NAME & NUMBER OF PROJECT: BROADSTONE 620 / BIRDEN MULTI-FAMILY WASTEWATER SERVICE EXTENSION REQUEST #3880

REQUEST: Wastewater Service Extension Request (SER)
recommendation

STAFF RECOMMENDATION: Recommend against approval.

SUBJECT: Broadstone 620/ Birden Multi-Family Wastewater SER #3880

Description of Improvements:

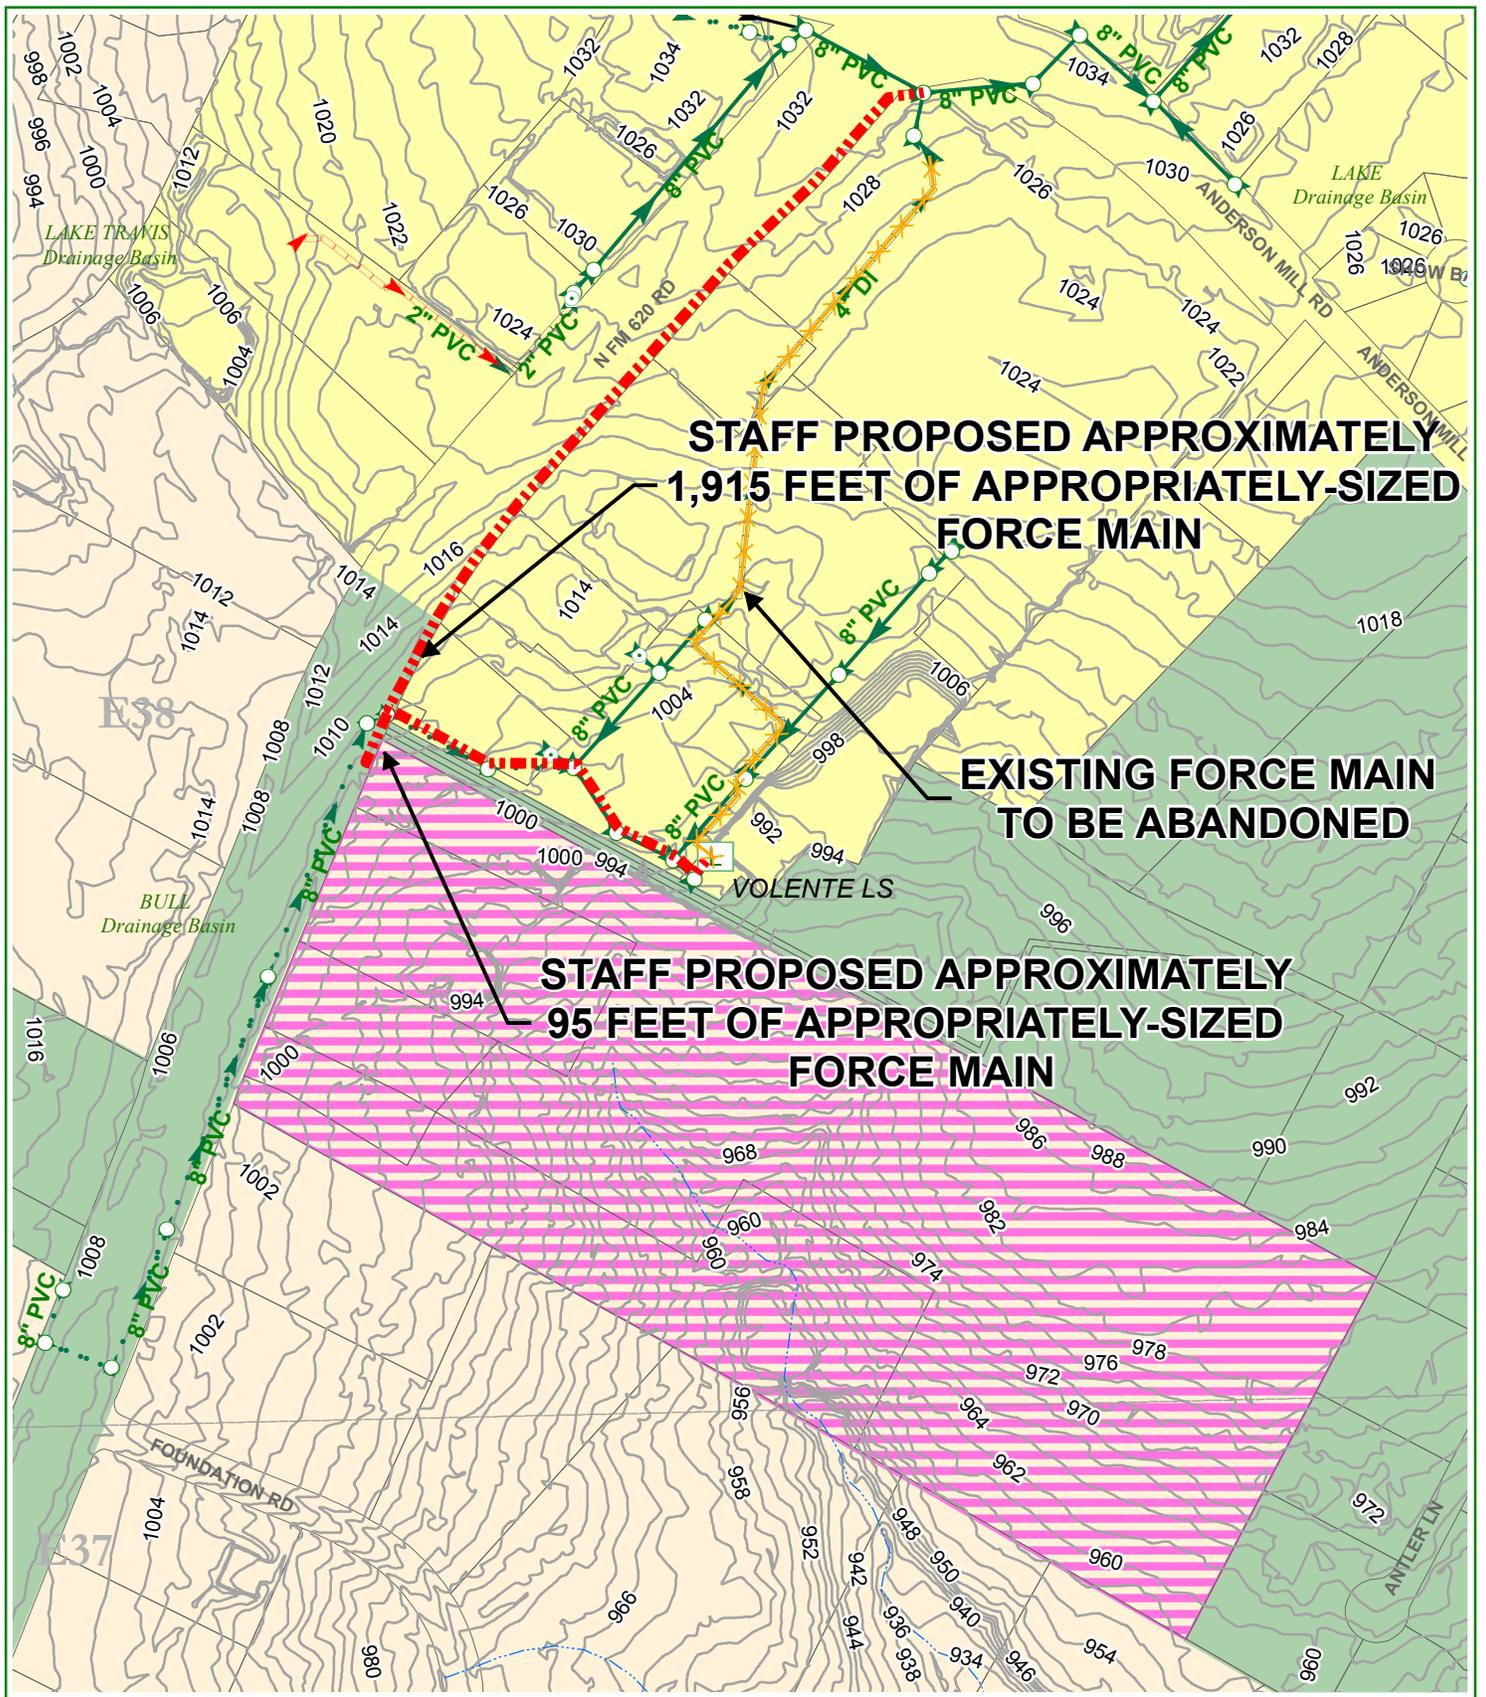
Applicant shall construct approximately 95 feet of appropriately-sized wastewater force main from the existing gravity wastewater main (Project no. 2015-0850; MH ID no. 270920), located in the N FM 620 right-of-way, south to the subject tract as shown on the attached map. Wastewater service to the subject tract shall be provided by a private, internal lift station and force main.

Applicant shall also upgrade the pumping capacity of the existing Volente Lift Station in order to adequately serve the additional wastewater flow proposed to be contributed by this development. Upgrades shall include, but are not limited to, replacement of existing pumps, generator, starters, and wet well. As part of the Volente Lift Station upgrades, applicant shall also construct approximately 1,915 feet of appropriately-sized wastewater force main from the existing 8-inch gravity wastewater main (Project no. 2002-0552; MH ID no. 132614) located at the intersection of N FM 620 and ANDERSON MILL RD, south along the N FM 620 right-of-way, and then east to the Volente Lift Station as shown on the attached map. The proposed wastewater force main shall replace the existing wastewater force main (Project no. 2004-0567) that currently serves the Volente Lift Station.
